# Access Compliance Report

## Public Rights-of-Way

Intersection ID: 25211	Main Street: SMITH_RD	Cross Street: SOUTHBRIDGE_FOREST_DR	Location: NE
ADA ID: 0946FA68D8E3	Ramp Type: Perp	Initial Pass/Fail: Fail	Overall Compliance: No
		Severity Score: 12.5

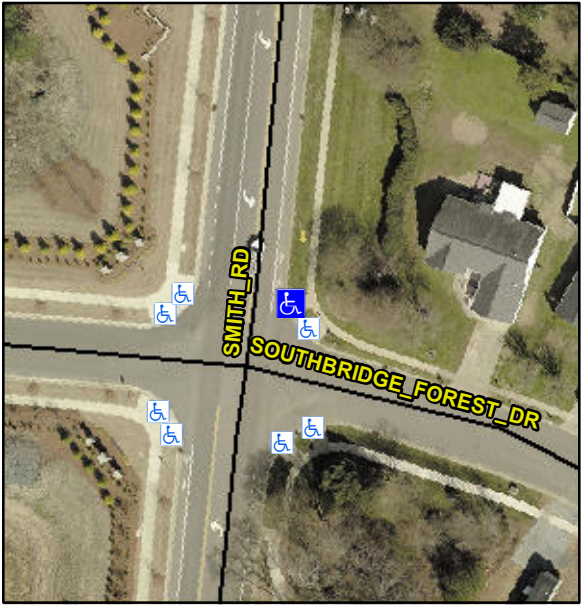
Compliance	Description	Data	Compliance	Description	Data
N/A	Ramp Length (in)	120.0	No	Ramp Slope (%)	10.8
Yes	Ramp Width (in)	89.0	Yes	Ramp XSlope (%)	0.4
N/A	Flare Type LT	N/A	N/A	Flare Type RT	N/A
N/A	Flare Slope LT (%)	N/A	N/A	Flare Slope RT (%)	N/A
N/A	Flare Traversable LT?	N/A	N/A	Flare Traversable RT?	N/A
N/A	Landing Length (in)	N/A	N/A	DWS Provided?	N/A
N/A	Landing Width (in)	N/A	N/A	DWS Contrast?	N/A
N/A	Landing Slope (%)	N/A	N/A	DWS Length (in)	N/A
N/A	Landing X Slope (%)	N/A	N/A	DWS Full Width?	N/A
N/A	Landing Curb? (Y/N)	N/A	N/A	DWS Offset (in)	N/A
N/A	Shared Landing?	N/A			
N/A	Gutter Ponding?	N/A	N/A	Gutter Slope (%)	N/A
N/A	Gutter Lip Ht (in)	N/A	N/A	Gutter X Slope (%)	N/A
N/A	Painted X Walk1?	No	N/A	Painted X Walk2?	N/A
	X Walk 1 Direction	To NW		X Walk 2 Direction	N/A
N/A	X Walk 1 Width (in)	N/A	N/A	X Walk 2 Width (in)	N/A
	X Walk 1 Slope (%)	4.3		X Walk 2 Slope (%)	N/A
	X Walk 1 X Slope (%)	1.7		X Walk 2 X Slope (%)	N/A

Codes/Mitigation Info/Possible Solution		Field Measurements/Component Compliance			
	Possible Solutions:				
	Remove & Replace Entire Ramp.				
	Surveyor Notes:				
	N/A				
	PROW/ADA:				
	Not Found, R304.2.2				
Street 1 Name	SMITH RD				
Stop Condition-Street 2	None				
Street 2 Name	N/A				
Stop Condition-Street 1	N/A				
Total Cost:		\$	1850.00
